# Access Compliance Report

## Public Rights-of-Way

Intersection ID: 10019873	Main Street: ARCHDALE_DR	Cross Street: N/A	Location:	N
ADA ID: 33CA0DDE5202	Ramp Type: PerpDiag	Initial Pass/Fail: Fail	Overall Compliance: No	Severity Score: 26.25

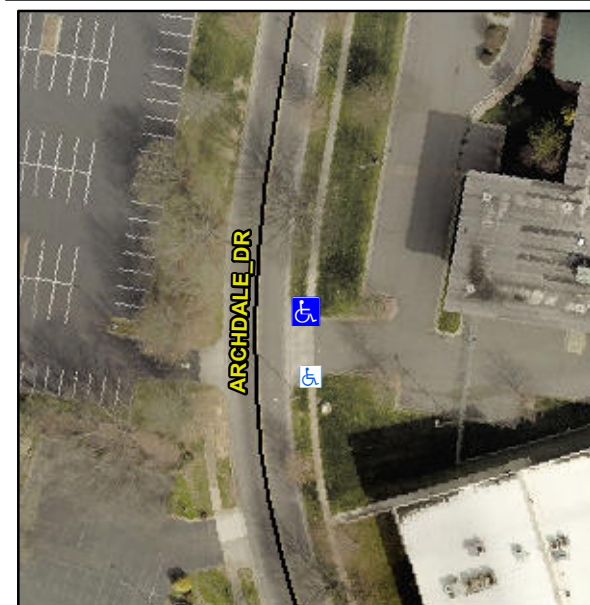
**Not Found, R304.2.2**

Compliance	Description	Data	Compliance	Description	Data
N/A	Ramp Length (in)	69.0	No	Ramp Slope (%)	14.8
Yes	Ramp Width (in)	48.0	Yes	Ramp XSlope (%)	2.1
N/A	Flare Type LT	N/A	N/A	Flare Type RT	N/A
N/A	Flare Slope LT (%)	N/A	N/A	Flare Slope RT (%)	N/A
N/A	Flare Traversable LT?	N/A	N/A	Flare Traversable RT?	N/A
N/A	Landing Length (in)	N/A	N/A	DWS Provided?	N/A
N/A	Landing Width (in)	N/A	N/A	DWS Contrast?	N/A
N/A	Landing Slope (%)	N/A	N/A	DWS Length (in)	N/A
N/A	Landing X Slope (%)	N/A	N/A	DWS Full Width?	N/A
N/A	Landing Curb? (Y/N)	N/A	N/A	DWS Offset (in)	N/A
N/A	Shared Landing?	N/A			
N/A	Gutter Ponding?	N/A	N/A	Gutter Slope (%)	N/A
N/A	Gutter Lip Ht (in)	N/A	N/A	Gutter X Slope (%)	N/A
N/A	Painted X Walk1?	No	N/A	Painted X Walk2?	No
	X Walk 1 Direction	To W		X Walk 2 Direction	To S
N/A	X Walk 1 Width (in)	N/A	N/A	X Walk 2 Width (in)	N/A
	X Walk 1 Slope (%)	1.9		X Walk 2 Slope (%)	2.4
	X Walk 1 X Slope (%)	0.3		X Walk 2 X Slope (%)	2.3

**Remove & Replace Curb Ramp With Two New Directional Ramps or Equivalent.**
